Groundwater Sustainability Plan - Sustainable Management Criteria and Monitoring Network Chapters
Public Review Draft- Spring 2021
Compiled Public Comments, July 14 2021

Re: Comments to Draft Sustainable Management Criteria Chapter

Re: NOAA's National Marine Fisheries Service comments on the Draft Chapter 3 of the Groundwater Sustainability Plan for the Vina Subbasin

Groundwater Levels for Well 20N02E09L001M

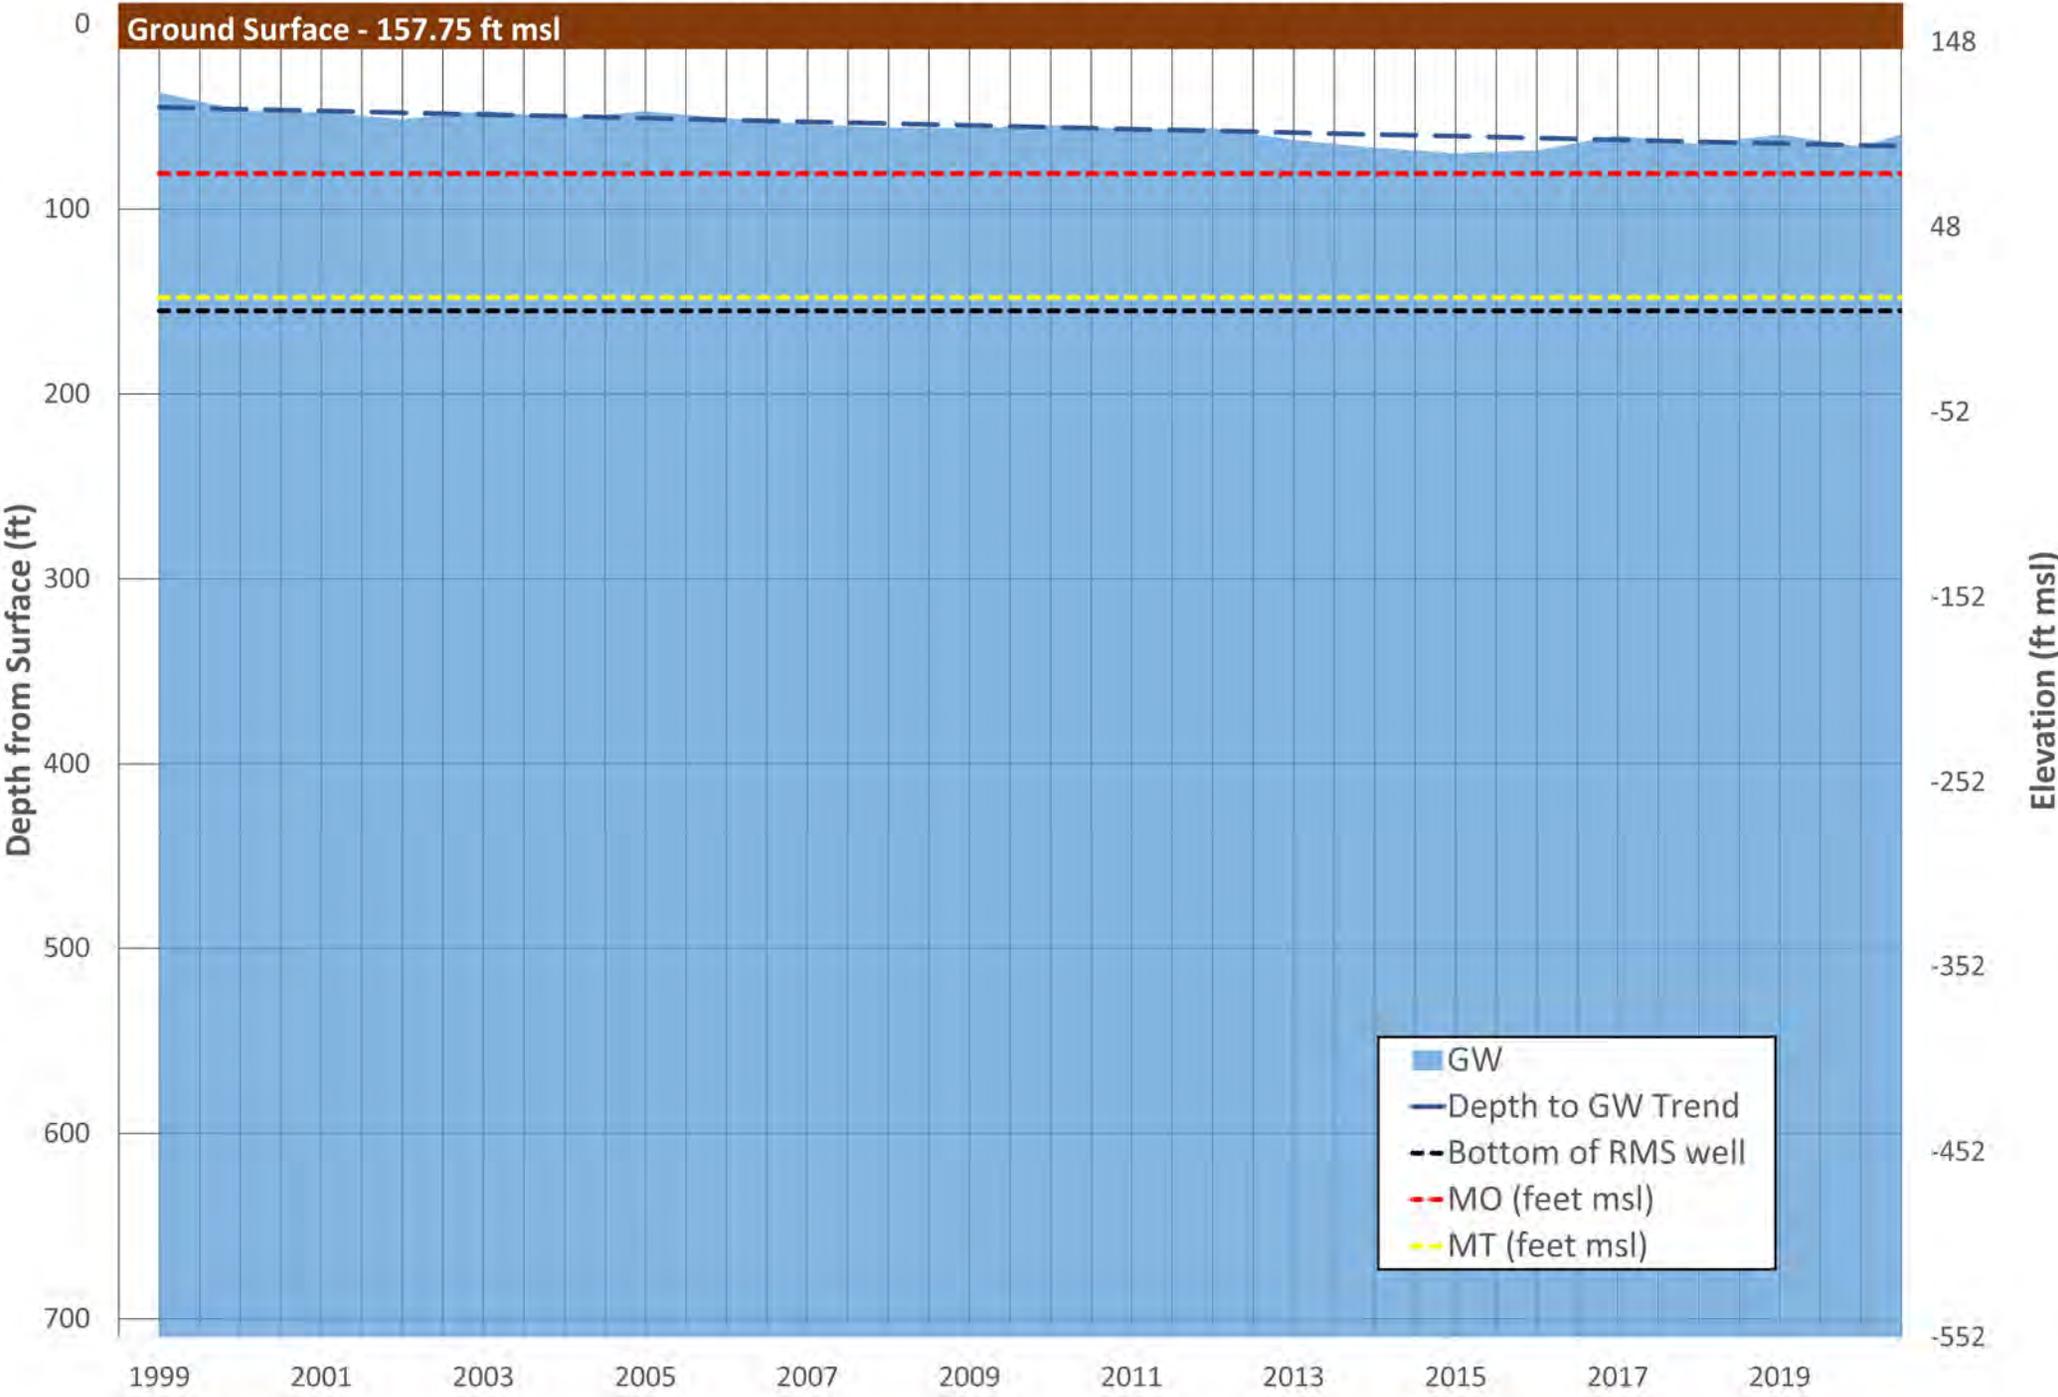
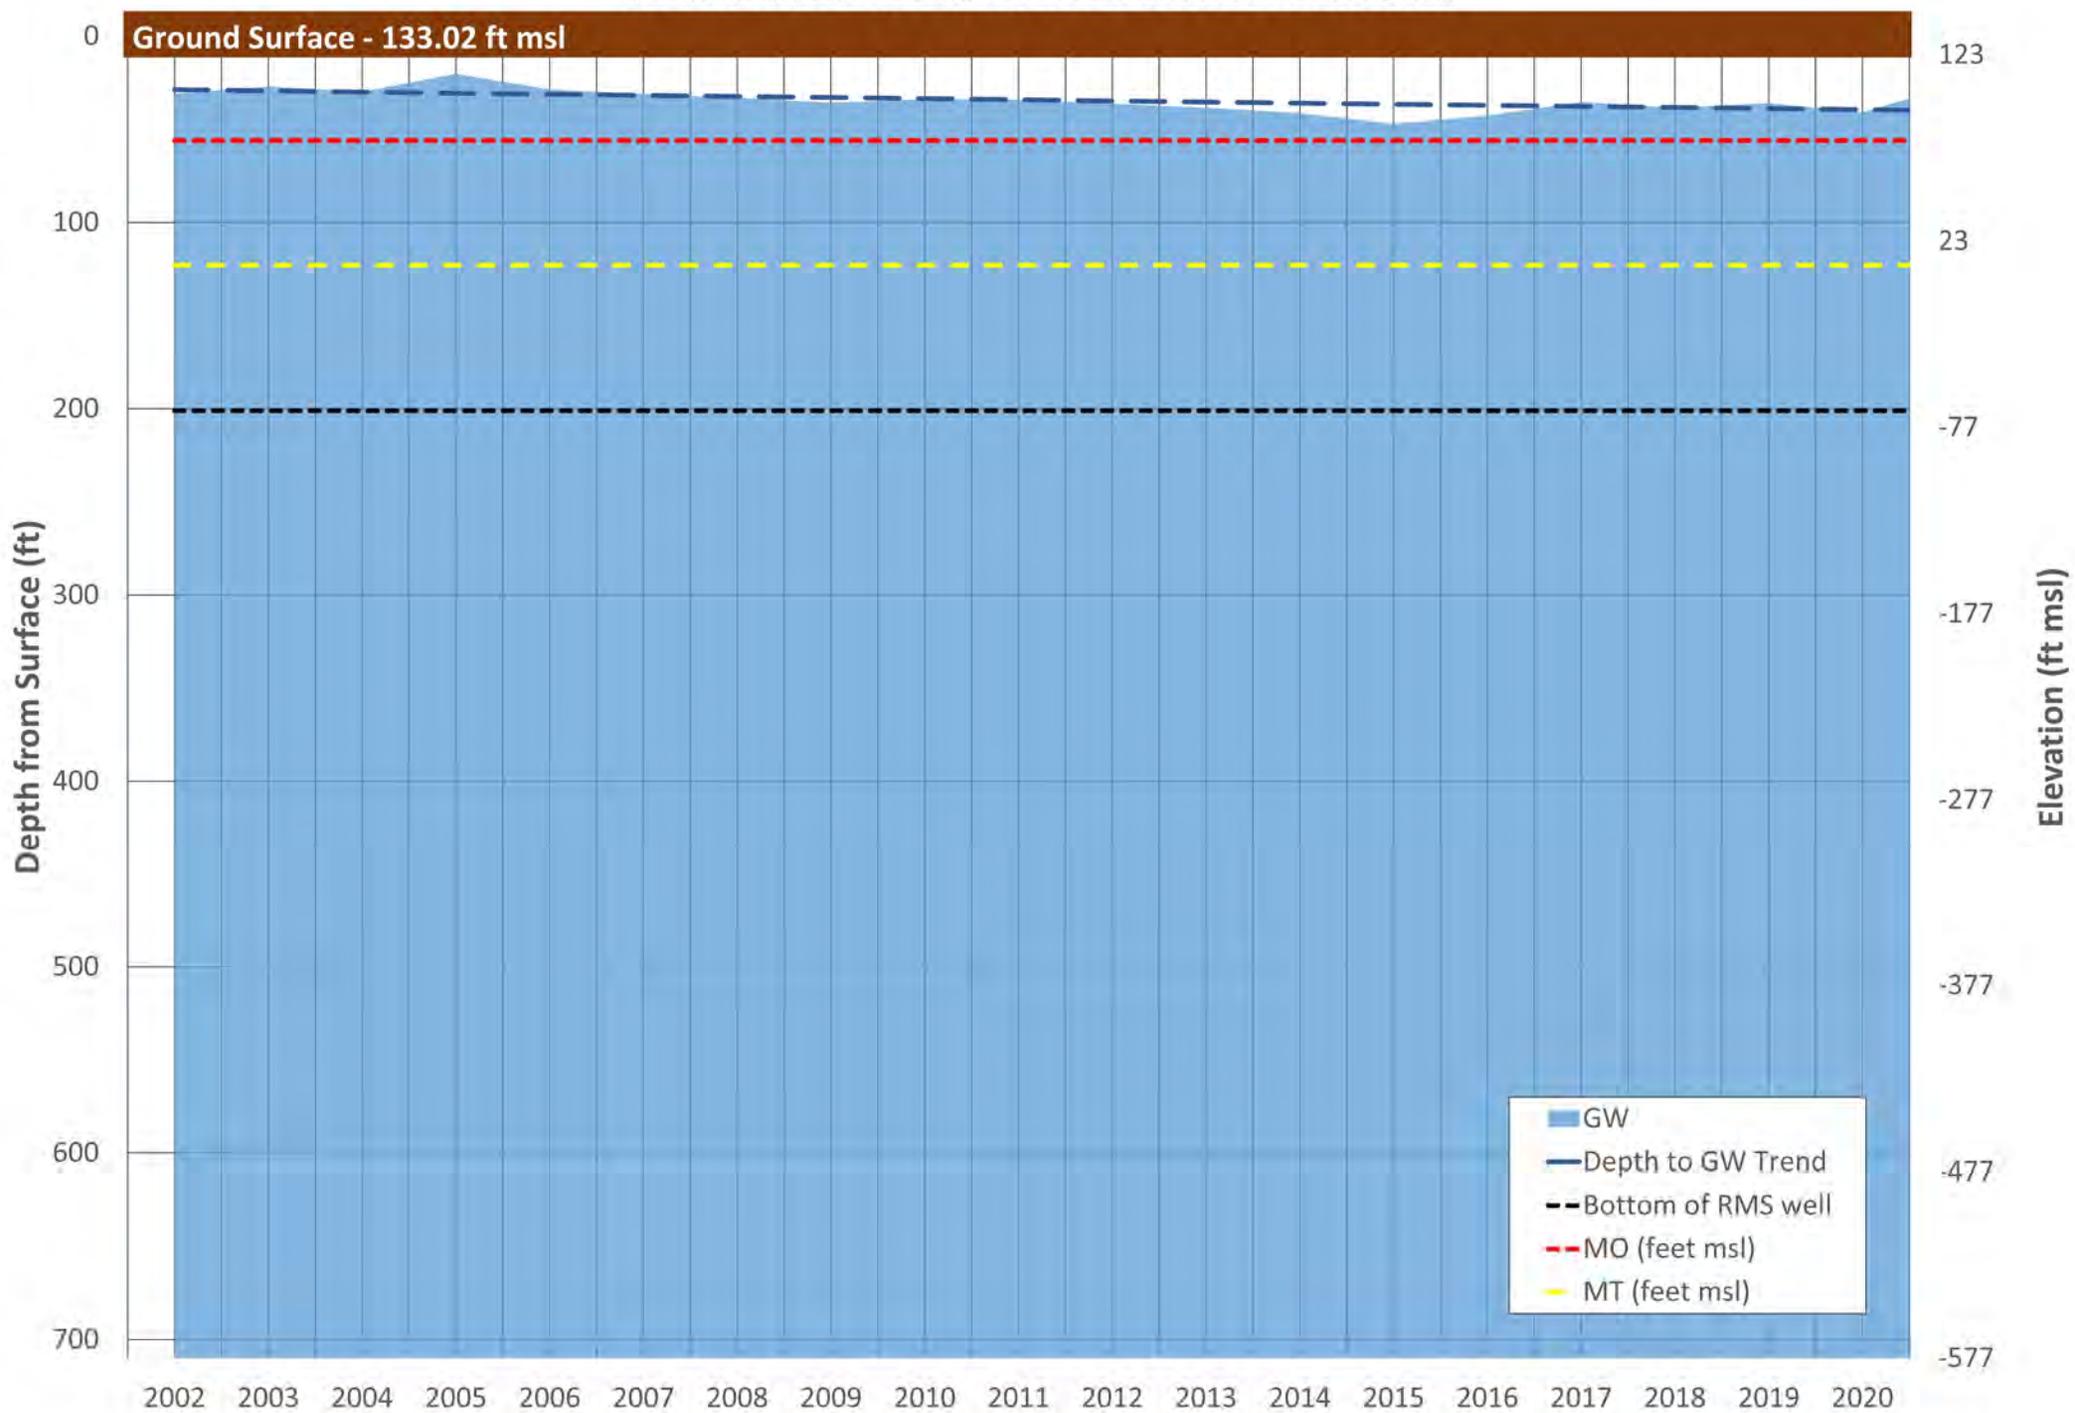
In recognition of the short timeframe to compile this information and meet the goal of the GSAs in getting the draft GSP out for public comment by September 2021, we hired Land IQ to propose polygons for the RMS wells in the Vina South Management Area. Enclosed is a map representing those polygons for the Vina South Management Area. You will find that a seventh zone is created as a result of this work.

The Margin of Operational Flexibility will need to be established for the polygon zones. As a starting point, we reviewed the Measurable Objectives (MO) and MT established for the Vina North Management Area and concluded that the average differential between the MO and MT was 67 feet. Consequently, the attached hydrographs for each RMS well (and polygon zone) show a difference of 67 feet between the MO and MT for the Vina South Management Area.
